MEMORANDUM

TO: PLANNING COMMISSION
FROM: SRI RAVALI KOMARAGIRI, PLANNER
THRU: BARBARA MCBETH, AICP, CITY PLANNER
SUBJECT: JSP 17-72 BERKSHIRE E-SUPPLY: REVISED PRELIMINARY SITE PLAN
DATE: AUGUST 17, 2018

CURRENT SITE PLAN

EMPLOYEE WALKING TRAIL AND CONNECTION TO PUBLIC TRAIL

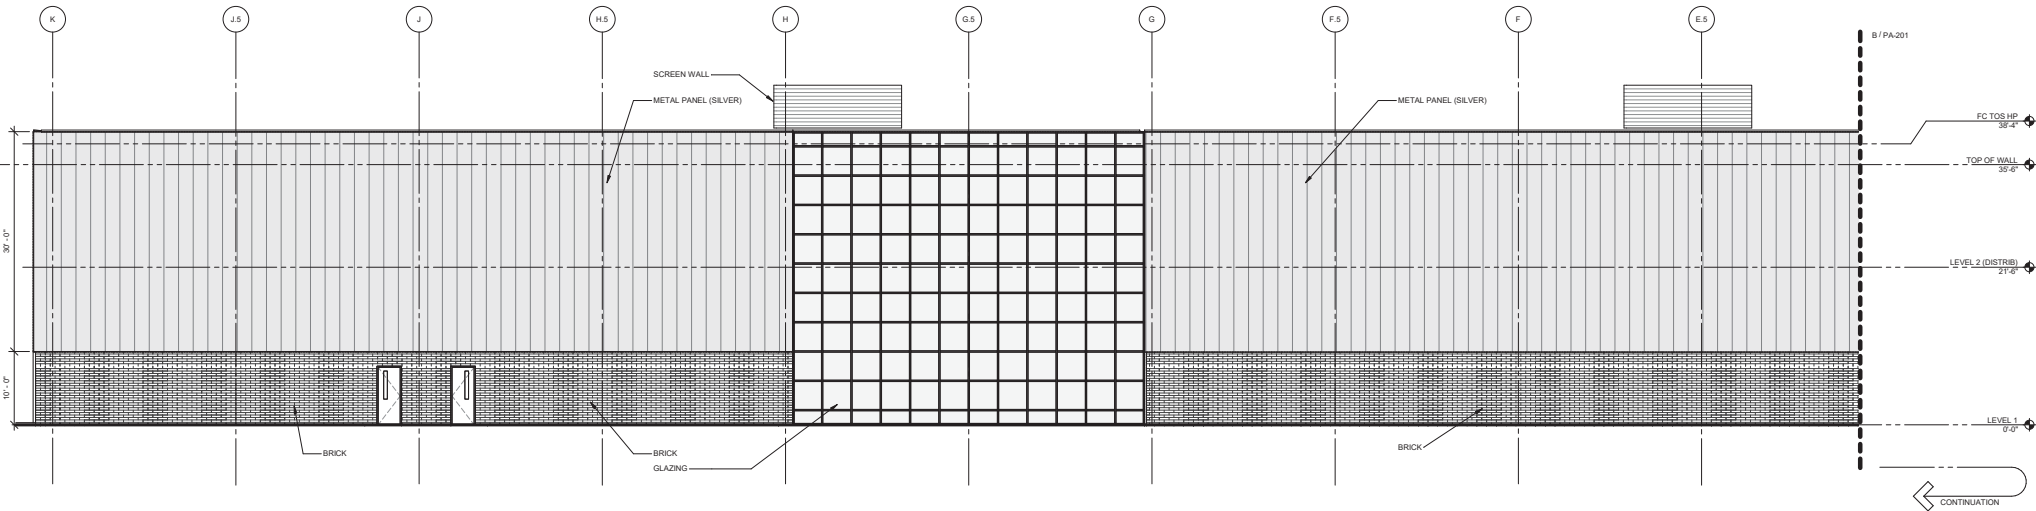
- The public trail identified on the south side of the Drain on the Landscaping Plan was never intended to be included in the Preliminary Site Plan. It was a concept that was being discussed by the Owner's design team that due to an oversight was left on for the Preliminary Site Plan submittal. This is why it was not identified on any of the other Site Plan sheets.

Sri, we have added a new feature that we would like to include in our recent submission set. It is a Public Trail on the south side of the Seeley Drain that the City of Novi could use to provide community access to the naturalized areas of the Berkshire eSupply site.

- v. Underage of Brick on the Fulfillment Center (30% minimum required, 25% proposed on the north facade);
- c. Removal of the public and private trails proposed on the Preliminary Site Plan for the south part of the site, based on the applicant's request as noted in this memo.

FC NORTH ELEVATION PA-201

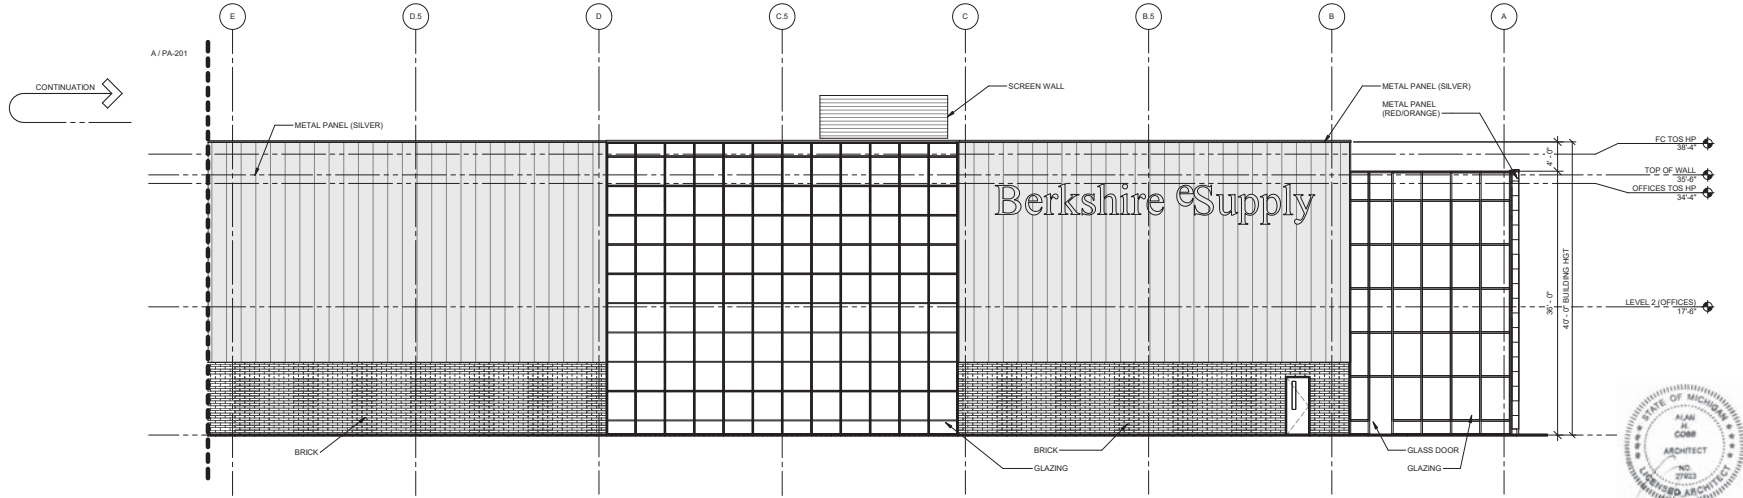
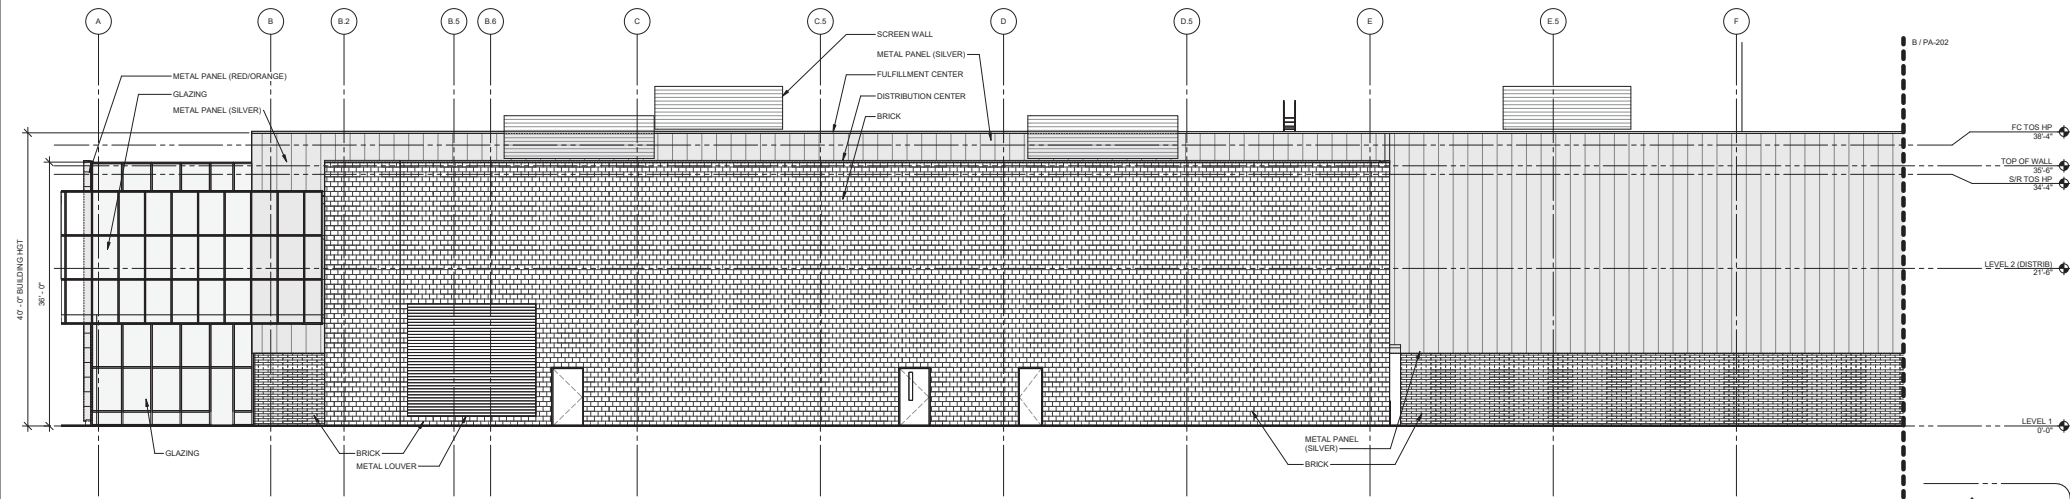
Fulfillment Center - As shown above the minimum percentage of Brick is not provided on the north facade and the percentage of Flat Metal Panels exceeds the maximum amount allowed by the Ordinance on the west, east and north facades. The Terracotta Tile from the original design, which was considered as Brick with respect to the Façade Ordinance, has been changed to orange colored Flat Metal Panels. As a result, the percentage of Flat Metal Panels now exceeds the maximum allowed by the Ordinance. In this case the orange colored Flat Metal Panels is a unique material with a textured and color similar to terra cotta. In response to our prior comments the applicant has increased the percentage of Brick on all facades.
